## Email 17 November Emma Fahey to Jon Bright

In considering the effects of the Waitaha hydro scheme in preparation of DOC's section 51 reports, and in discussion with our technical experts, a few issues have come up that we seek clarification from Westpower on. We imagine that the Panel may also have similar queries as it gets more into the detail. We have set these out below, with references to the information in the application documents to explain where we are coming from where relevant. We would appreciate a response to these issues asap.

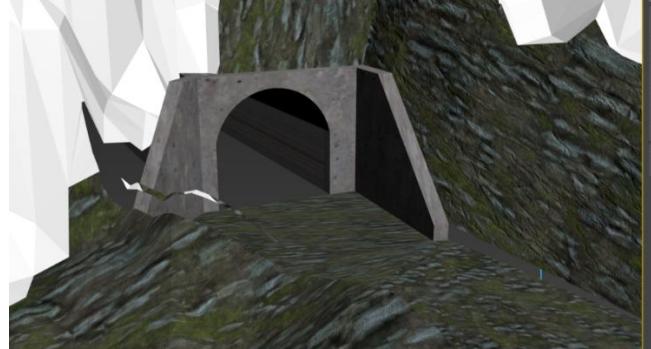
Is it correct that the access tunnel portal at Kiwi Flat will have wingwalls around it	<p>Clarification Has Mr Bentley considered?</p>	<p>Yes, section 3.4 page 72 of the substantive application lists concrete wingwalls at both ends of the access tunnel.</p> <p>The model has it in it (see image below of the model):</p>

DOC concern	Requests	Response
		 <p data-bbox="878 530 1163 557"><i>Image of the 3D model</i></p> <p data-bbox="878 625 2084 790">The Visual Simulation at Year 1 clearly illustrates this, with the Visual Simulation at Year 10 demonstrating how the effectiveness of the LMP can apply to this part of the project to ensure that it meets the landscape objectives that are outlined within <b>Appendix 1, paragraph 5.1</b> of the Landscape Effects Assessment. Particularly:</p> <p data-bbox="968 816 2084 1017"><i>Consideration will be given where practical to implement measures that continue to reduce the visual impact of the intake structures and help blend this area in with its local setting. For example, there may be opportunities to further refine the design of the intake structures, (refer to Visual Simulation IN1) by, for example, rounding of corners, faceting and texturing of surfaces or aligning exposed faces to match the profile of rock on each side.</i></p> <p data-bbox="968 1043 2046 1203"><i>The intake portal will get completely submerged with big floods and on each event will get coated with rock flour and silt from the river, and decorated with driftwood, as does the cliff and banks on either side. Moss and lichen will grow; within a short time, it is likely to show quite a weathered surface.</i></p> <p data-bbox="968 1229 2061 1389"><i>It is also proposed to minimise disturbance around the intake interface with the river rock. There is likely to be some stabilization required above the intake structure. While shotcreting is commonly used as a stabilisation treatment (and has been used for the portal area at the Amethyst Scheme), alternative treatments may be used within this sensitive location.</i></p>

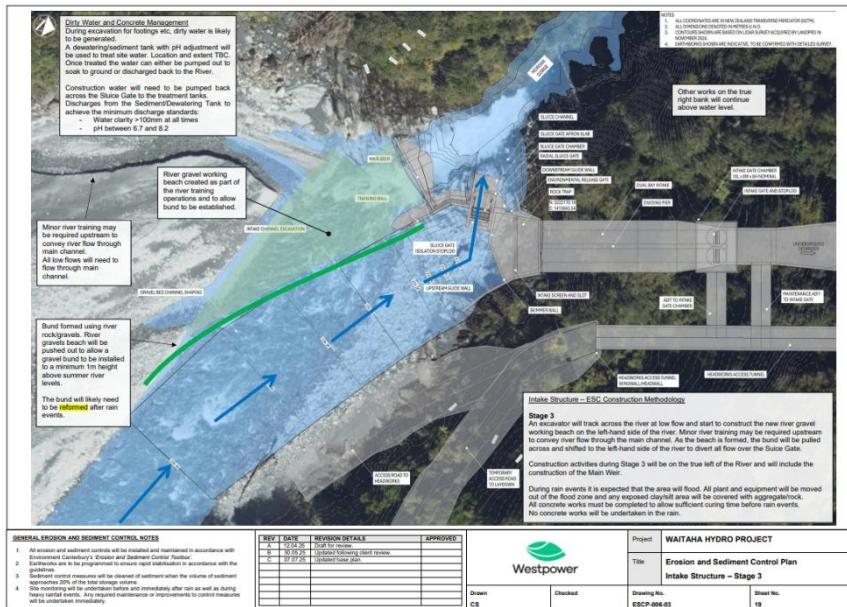
2. **Wingwalls or other strengthening needed for access tunnel portal** – Is it correct that the access tunnel portal at Kiwi Flat will have wingwalls around it? There is discussion in the Project Overview Report Part 1 (POR) that there will be, but the design images and simulations, and Mr Bentley's Report and the draft Landscape Management Plan don't show or mention them for the access tunnel portal. Please could you clarify whether wingwalls are going to be constructed here?

- b. POR page 73 notes that the access tunnel portal will have small wingwalls on both sides.
- c. The draft Landscape Management Plan notes at paragraph 2.3(c) that:

Figure 2 - Access Road and Construction Staging Area 1 at Intake

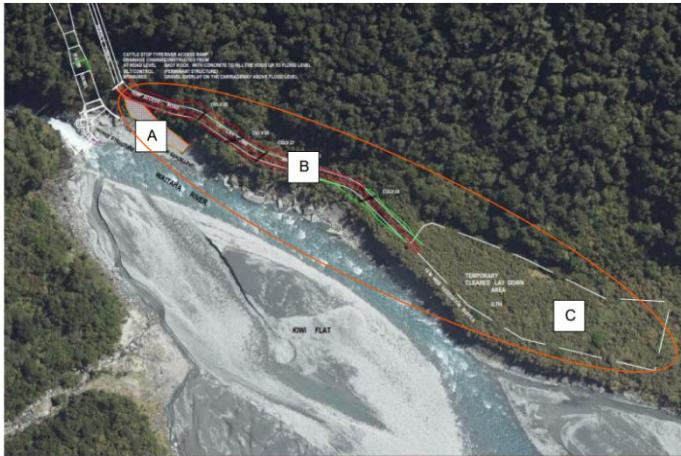
5. **Route from access tunnel portal to riverbed** – While Mr Bentley’s Report refers to it, the visual simulation of the intake structures (IN1) does not include the 60m long x 12m wide access route to the riverbed from the access tunnel portal needed for the 12 – 20 tonne excavator to get down to riverbed level to do maintenance work in the river and at the intake. The access route is however referenced in the documents and shown on various plans. It will be visible from at least some locations, given the comment in Mr Bentley’s Report noted below. Please could you clarify why the access route is not shown in the simulations. If you do have any images, please could you supply them to us.

- POR page 73 notes: “The final portal location is subject to further geotechnical work, however it is estimated that it will be approximately 10 m distance (horizontally) from the water portal, with *the floor approximately 6 m higher than the top of the water portal*”
- Figure 2 at para 4.21 on page 21 of the POR show this access route as (A) (and the construction road and laydown areas as (B) and (C), as does Figure 22 in the Appn/AEE shown above. But the relevant simulation (IN1) does not show any of these works, and this is the only simulation for this area looking towards Kiwi Flat:

Confirm what simulations the route from access tunnel portal to riverbed is included in	<p>Clarification (and rationale for why not).</p> <p>Supply any images if included</p>	<p>Intake Simulation VS1:IN1 and VS2:IN2 in Appendix 27<sup>3</sup> includes the access to the riverbed on the left-hand side of the image. The access is formed using in-situ river gravels and we anticipate that this access will need to be reformed following significant flood events. These are labelled in the Graphic Supplement at the end of Appendix 27.</p> <p>As outlined in the Visual Simulation discussion, the Visual Simulations represent a fixed, single shot view based on a horizontal field of view of 40° (65° for IN1) with a reading distance of 50cm at A3 size (and 28cm for IN1). The reason that IN1 is different from the other Visual Simulations is due to its closeness to the subject enabling a slightly wider view to be obtained of the surrounding area. It is acknowledged that a wider panorama of the same view would be captured when standing in that spot. Therefore, only the elements in the 40° view (or the Visual Simulation visual extent) are depicted in that view.</p> <p>VS1:IN1 includes the access road, however it is mostly obscured from view primarily by the angle of the view and also partly by rocks and boulders in the foreground.</p> <p>VS2: IN2 includes the access route to the riverbed and is depicted in the left-hand part of the image.</p>

- Drawing WP-WTH-C-400 on page 10 of the Conceptual Scheme Design Drawings as follows:

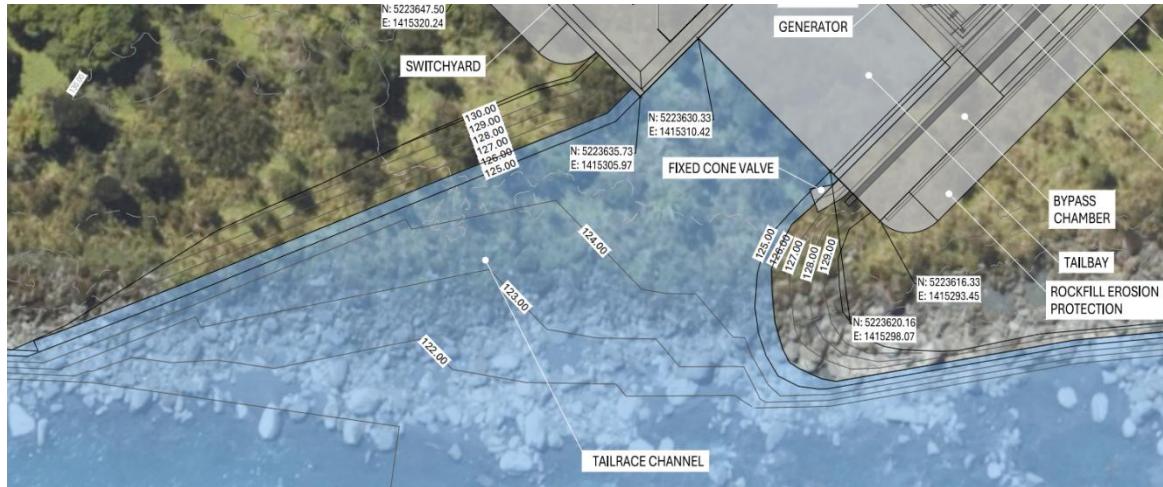
8. **Tailbay and tailrace at Power station site** – while the tailbay and tailrace structures are shown on the Conceptual Scheme Design Drawings and mentioned in the POR, the visual simulations of the Power station and associated infrastructure do not show these structures. Could you please clarify why

not, and if you have any images, please could you supply them to us.

Tailbay and tailrace at Power station site excluded from simulations	Supply images or explain rationale for why excluded	<p>These aspects have not been excluded; they are labelled in the accompanying Graphic Supplement. In all respects, the reason these elements are not highly visible is the angle of view, coupled with the in-place mitigation that is implemented as part of the construction of the Powerhouse area.</p> <p>Powerhouse Simulation VS3:PH1 shows the proposed view from beyond where the DOC track will be diverted away from the powerhouse. From this vantage point, the tailrace and tailbay will be largely obscured by vegetation.</p> <p>VS4:PH2 is taken from the river and shows the water leaving the tailrace and the fence excluding the public from the tailrace area.</p>

DOC concern	Requests	Response
		From upriver, (VS6:PH4) the tailrace is obscured from view by the flood barrier which is constructed of large river boulders.
ESCP error	Wrong arrow	Noted. The arrow on the first box text box of sheet 16, page 44 of the draft Erosion and Sediment Control Plan should point to the shorter, permanent access track, not the longer, temporary construction track.
